**CITY OF SACRAMENTO
DEPARTMENT OF PLANNING & DEVELOPMENT
ZONING ADMINISTRATOR
1231 I Street, Sacramento, CA 95814**

ACTION OF THE ZONING ADMINISTRATOR

On Tuesday, September 26, 1995, the Zoning Administrator approved with conditions a special permit to allow two driveways off the same side of the street for a second residence on a corner lot and a special permit to reduce the driveway depth from 20 to 15 feet for the project known as Z95-074. Findings of Fact and conditions of approval for the project are listed on pages 4-6.

EXHIBIT B

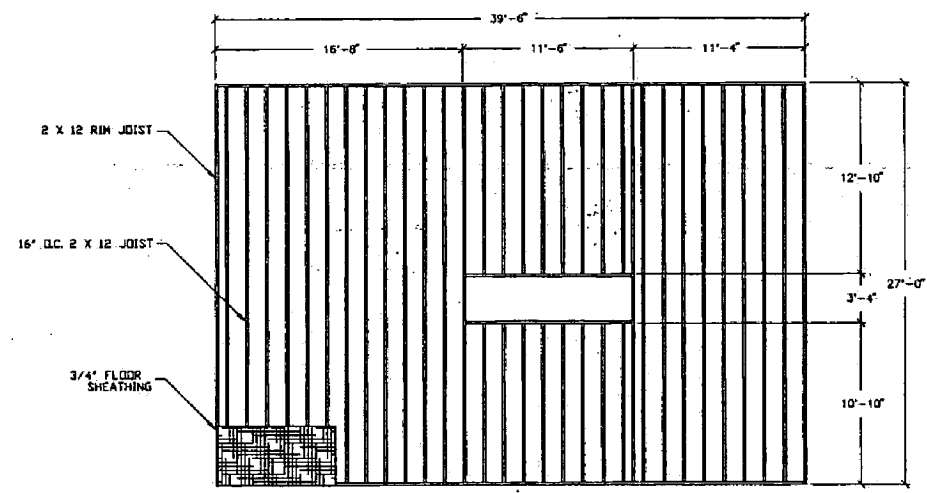
- f. use a minimum of 25 year laminated dimension composition shingles;
 - g. one window shall be added on the second floor in the closet area of the master bedroom;

EXHIBIT D

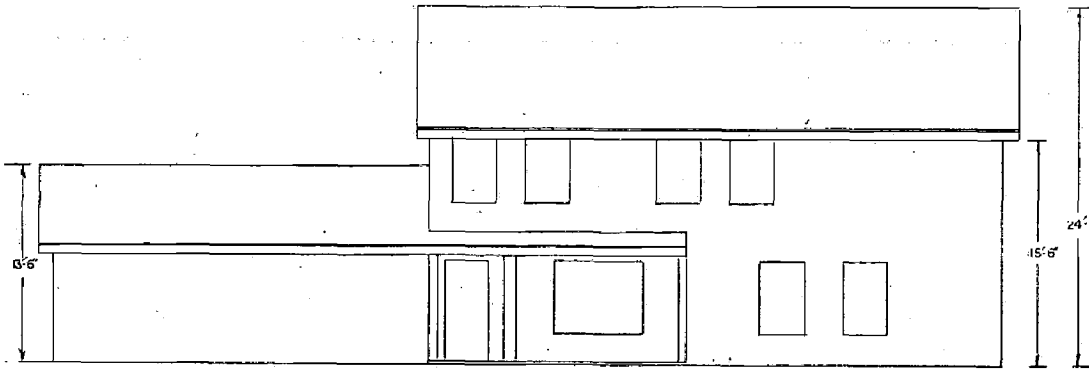
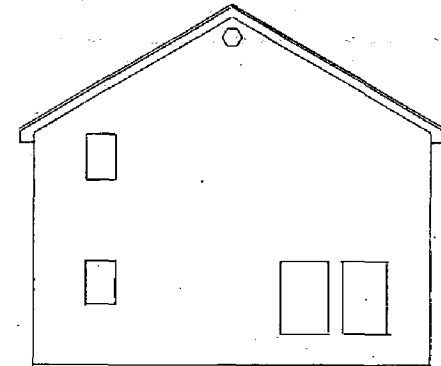
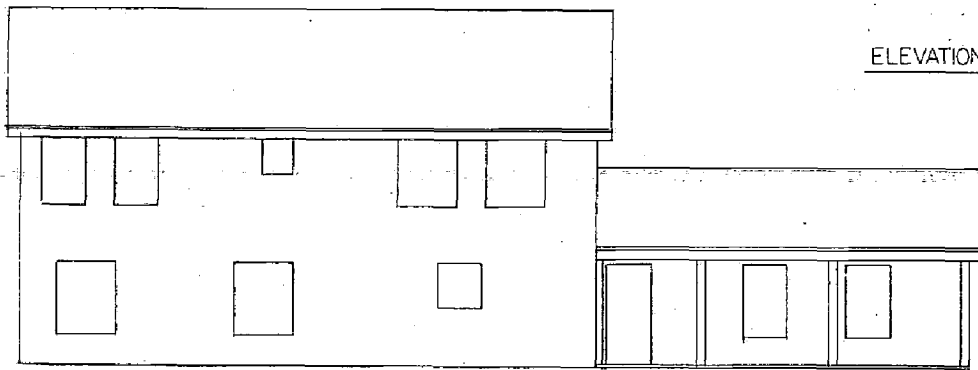
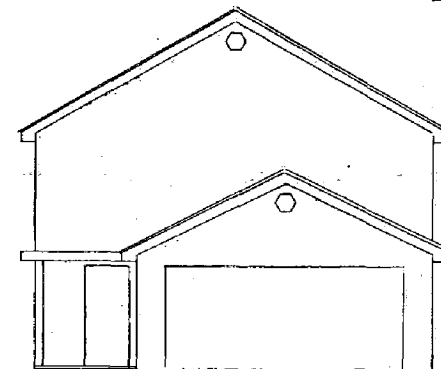
- a. no mechanical equipment on the roof;
 - b. the garage door shall be metal sectional doors subject to Planning staff review and the plans shall be revised to locate the garage door on the north elevation with access off of 51st Avenue;

- i. the north, east, and west elevations shall have horizontal lap siding.
- 2. The applicant shall repair the exterior of the front unit to include as a minimum:

$65.6' \times 15' = 984 \text{ sq. ft.}$	required rear yard area
$145' =$	the width of the lot minus the front 25' front setback
$984 \text{ sq. ft.} - 145' = 6.8'$	substituted rear yard width
$145' \times 6.8' = 986 \text{ sq. ft.}$	substituted rear yard area along south property line
- 10. No doors shall be permitted on the west elevation (to meet the required court yard requirement).

EXHIBIT E

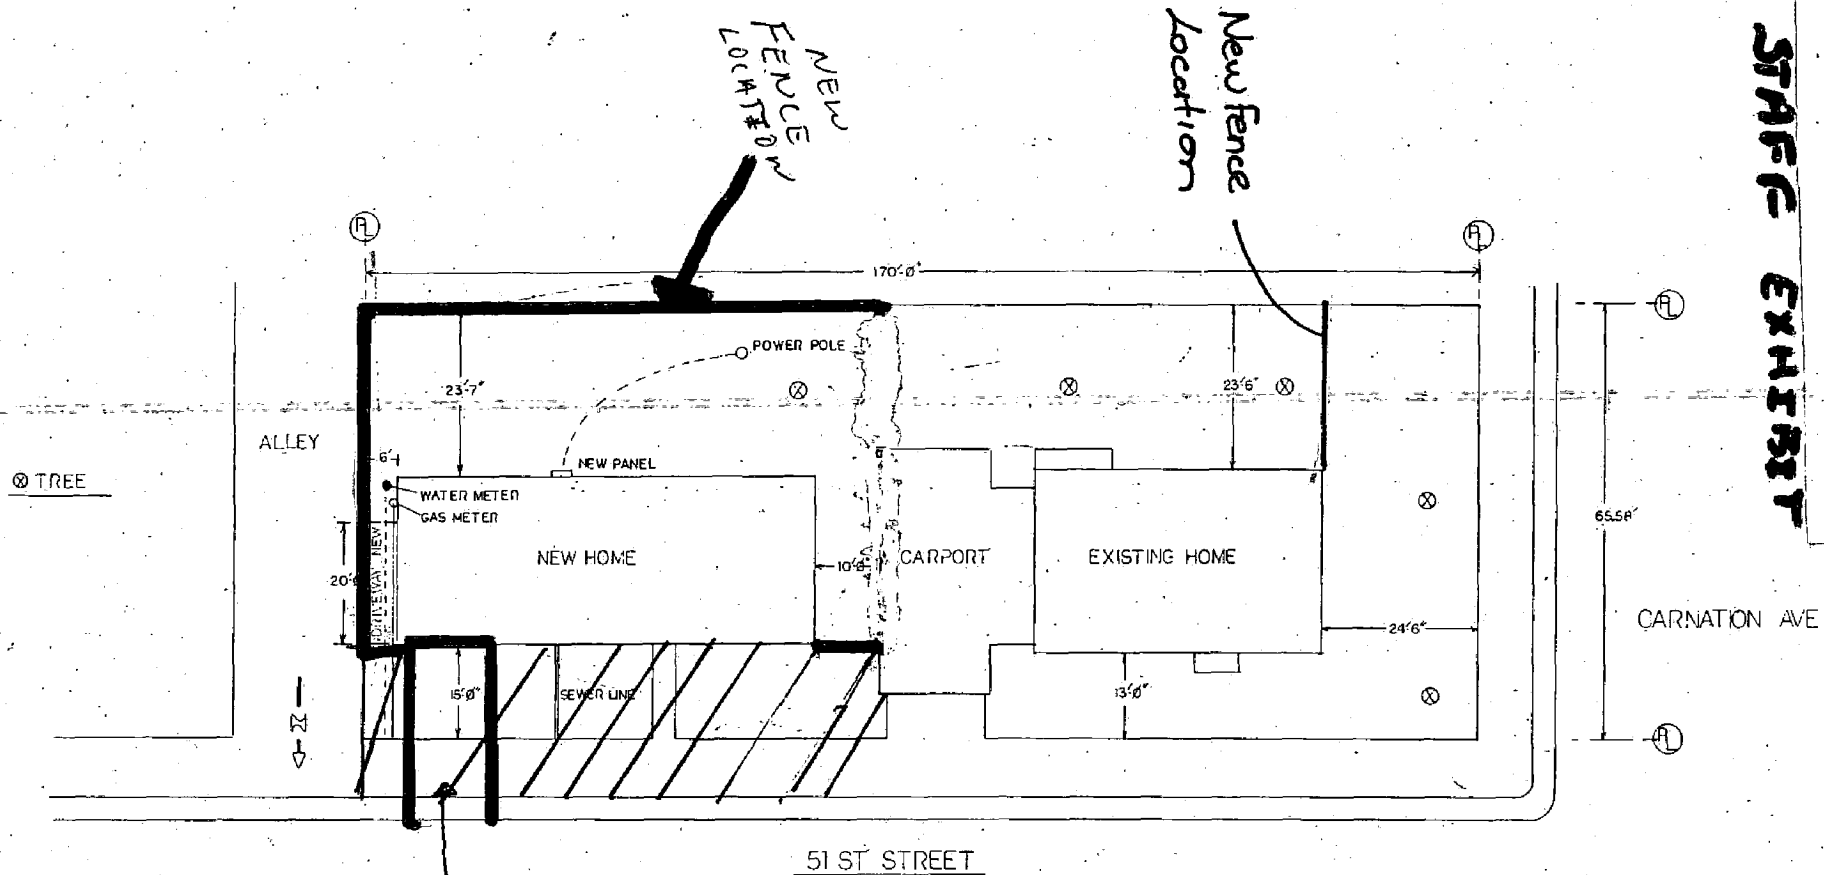
Area to be landscaped

Revise TO Have Drive way AND Garage door HERE

- e. the front (north side) area of the proposed unit shall be landscaped with sod, shrubs, at least one tree, and irrigated with an automatic sprinkler system (see Staff Exhibit E);

- 4. Only one water service is allowed per parcel and any new service shall be metered.
- 5. Size, design, exterior building materials, and location of the proposed residence shall conform to the plans submitted. (The plans shall be revised to relocate the garage entrance off of 51st Avenue instead of the alley.)
